**Subject: Beaver Valley Power Station, Unit Nos. 1 and 2  
BV-1 Docket No. 50-334, License No. DPR-66  
BV-2 Docket No. 50-412, License No. NPF-73  
Supplemental Information for License Amendment Request Nos. 334  
and 205 (TAC Nos. MD4290 and MD4291)**

Beaver Valley Power Station, Unit Nos. 1 and 2  
Supplemental Information for License Amendment Request Nos. 334 and 205  
L-07-105  
Attachment 1

Revisions to License Amendment Request (LAR) Nos. 334 and 205

Figure D-7:  
Available NPSH for Unit 1 RS and LHSI Pumps

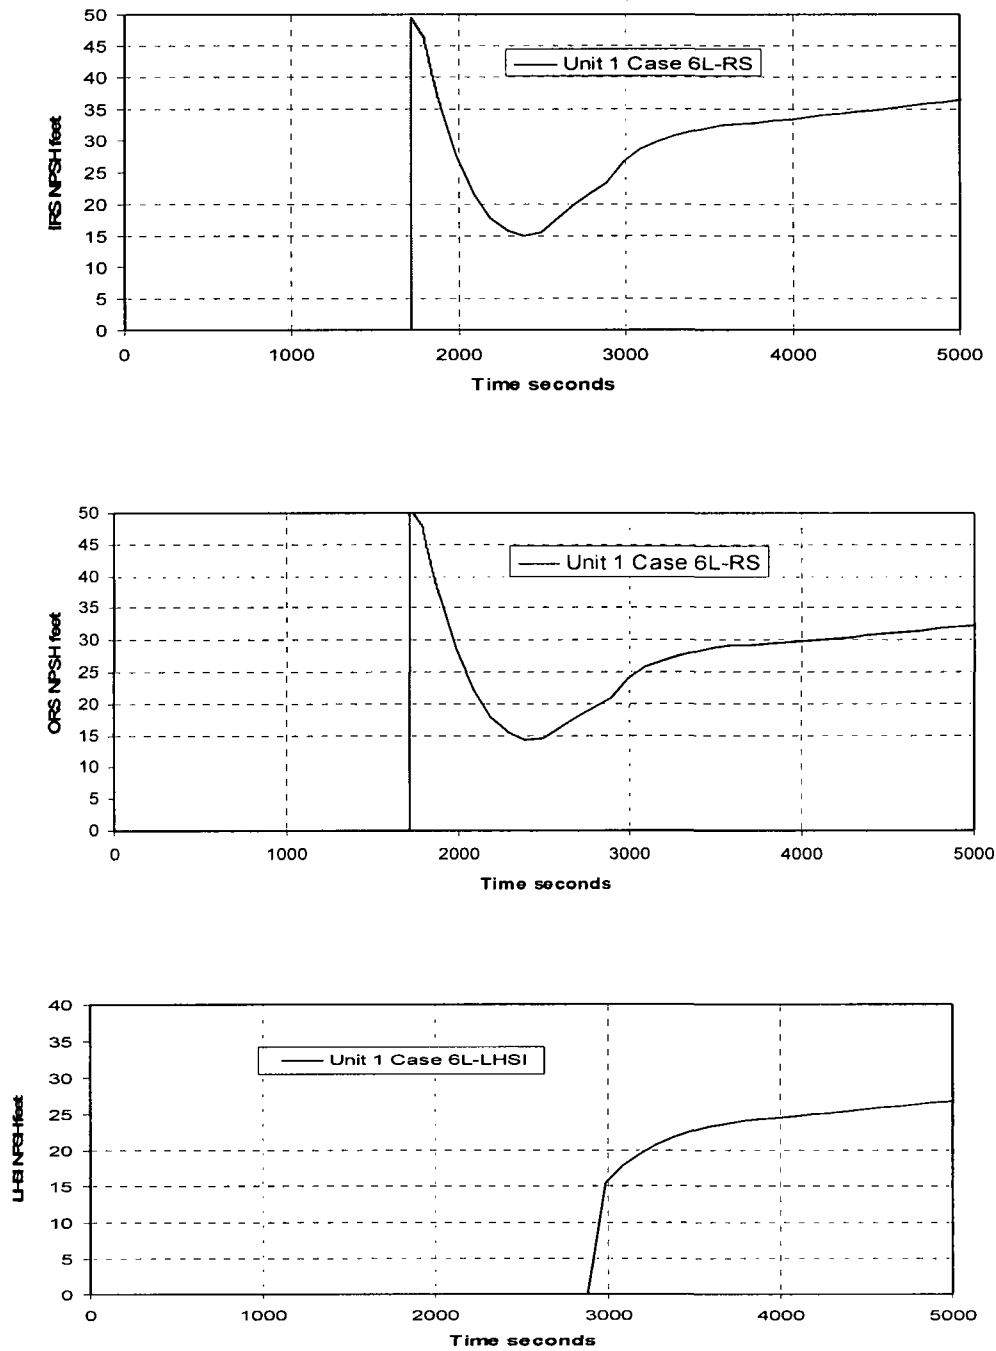
FirstEnergy Nuclear Operating Company (FENOC) has identified a non-conservative assumption used in the instrument uncertainty calculation performed in support of the subject LARs. The non-conservative estimate of Refueling Water Storage Tank (RWST) level uncertainties for Recirculation Spray System (RSS) pump start is limited to Beaver Valley Power Station (BVPS) Unit No. 1 (LAR 334). The condition does not extend to BVPS Unit No. 2 (LAR 205). The correction to the instrument uncertainty calculation results in a reduction in the Net Positive Suction Head (NPSH) available to the BVPS Unit No. 1 RSS pumps of approximately 0.6 feet. The reduced available NPSH is adequate to support strainer installation. The revisions to the instrument uncertainty calculation do not require any changes to the Technical Specification amendments proposed in Reference 1.

Previously submitted analysis, figures and tables affected by these corrections were provided in the License Amendment Requests submitted on February 9, 2007. For ease of review, revised information on affected pages, identified as Revision 1, is included in this attachment. Areas of change are marked with revision bars.

Tables D-9 and D-10 show the limiting NPSH results for the RSS and LHSI (Unit 1 only) pumps for Unit 1 and Unit 2, respectively. The available NPSH transient results for the most limiting cases are shown in Figures D-7 and D-8. Consistent with the current licensing basis, Unit 1 continues to credit containment overpressure for calculating available NPSH. At Unit 2, the analysis assumes that the sump vapor pressure is equal to containment pressure consistent with the Standard Review Plan Section 6.2.2 guidance. This is also consistent with the current licensing basis.

The Unit 1 results show a decrease in the available NPSH for the Inside Recirculation Spray (IRS) pumps and an increase for the Outside Recirculation Spray (ORS) pumps. This is primarily due to the modeling change for the direct QS injection flow as discussed above in the input changes section. The minimum NPSH margin for the RSS pumps is 4.3 feet. The Unit 1 LHSI pump available NPSH decreases when compared to the current analysis. This is due to the higher sump temperature (and vapor pressure) at switchover to cold leg recirculation. The minimum NPSH margin for the LHSI pump is 5.6 feet.
